NEWS Aftermarket

74191901e

AM01 / 2019

Conversion of brake shoes and return springs for BPW stub axle MVBFST 10010 and BPW steering axle stub MVBFLST with brake SN 4218

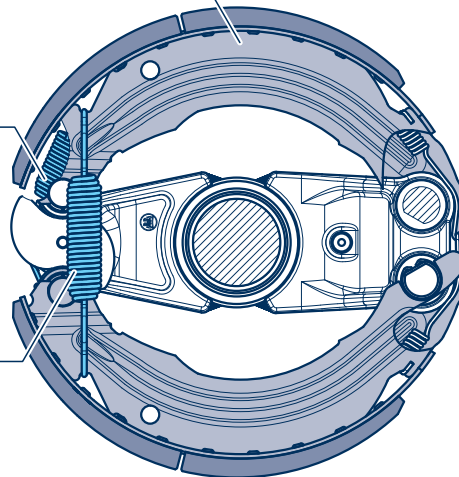
As of March 2019, certain BPW stub axles and BPW steering axle stubs will be provided with modified brake shoes and return springs, which react less sensitively to vibrations in the vehicle and on the axle.

To enable existing versions to also use the modified brake shoes and return springs for repairs, the previous components will be eliminated and replaced by repair kit 09.801.08.84.0.

Brake shoe assembly old: 05.091.46.32.1

replaced by

Brake shoe assembly new: 05.091.46.41.1

Return spring old: 03.397.34.20.0

replaced by

Return spring new: 05.397.34.22.0

Return spring old: 03.397.46.14.0

replaced by

Return spring new: 05.397.46.15.0

Repair kit **09.801.08.84.0** for the defined BPW stub axle or steering axle stub comprises:

4 x Brake shoe assembly	05.091.46.41.0
2 x Return spring	05.397.34.22.0
2 x Return spring	05.397.46.15.0
